## SUNDRY NOTICES AND REPORTS ON WELLS

8. Well Name and No.  
MITCHELL 21 FEDERAL 19. API Well No.  
30-015-2855910. Field and Pool or Exploratory Area  
CEDAR CANYON DELAWARE11. County or Parish, State  
EDDY COUNTY, NM

OXY USA Inc. - Proposed  
Mitchell 21 Federal #1  
API No. 30-015-28559

**Permanent Abandonment of Federal Wells  
Conditions of Approval**

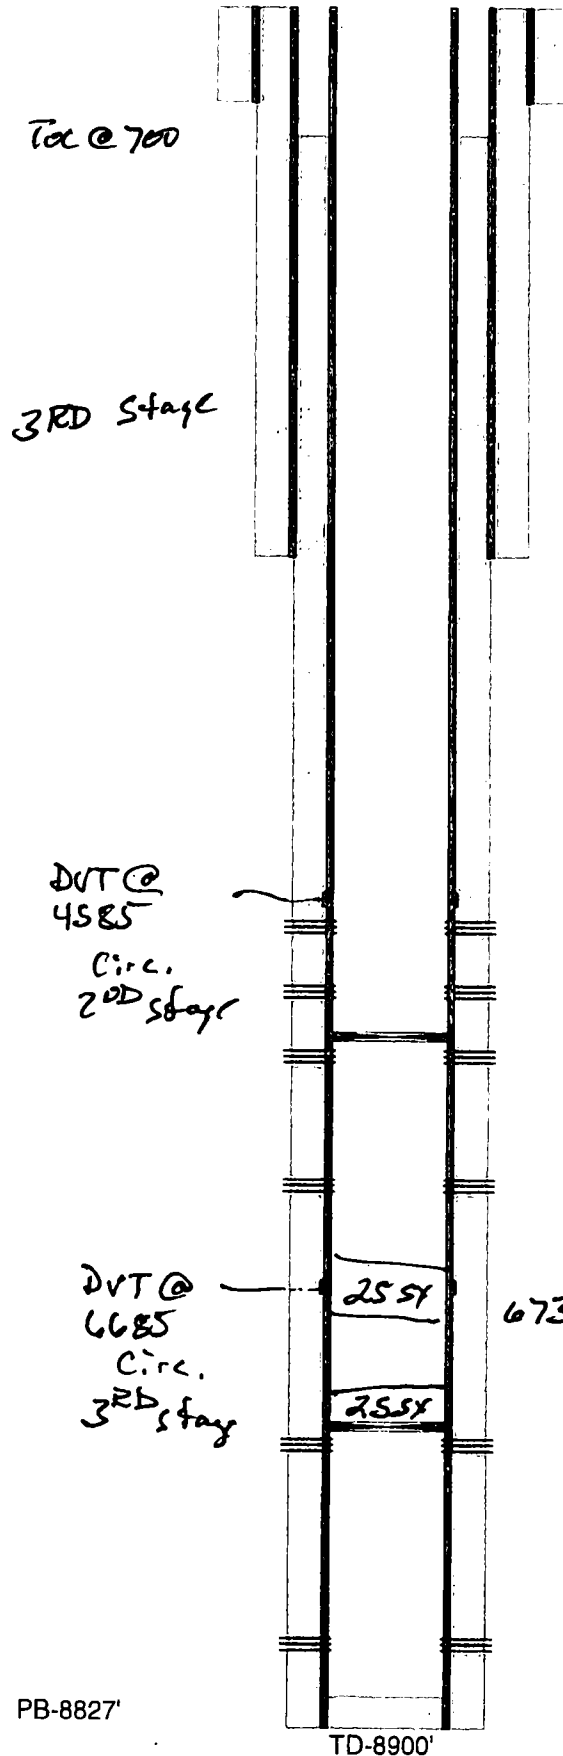
17-1/2" hole @ 580' ✓  
 13-3/8" csg @ 580' ✓  
 w/ 680sx-TOC-Surf ✓  
 1" Surf from 80' ✓  
 Top salt 680' ✓  
 Base salt 3030. -

Perfs @ 5211-5236' NO Record (cas)

Perfs @ 5624-5642' NO Record (sal)

6735-6565 BS 6650

Perfs @ 7634-7676' NO Record (su)

Remedial Work Needed: Drill out CIBP's  
Clean hole to 7550' Cap CIBP w/ 25sx  
cmt. Spot plug across 1st DVT & Tap  
Bore Spring from 6735 - 6565. 25sx  
min. WOC Tag.

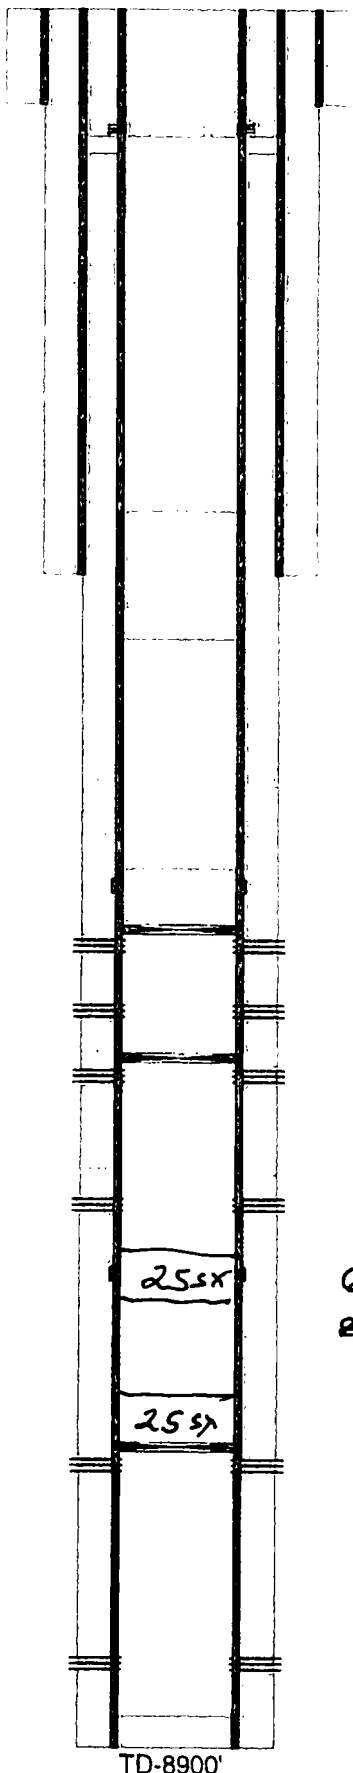
195sx @ 630'-Surface

2980 - 2670  
30sx @ 2930-2700' WOC-Tag

CIBP @ 4836' w/ 40sx to 4535' WOC-Tag
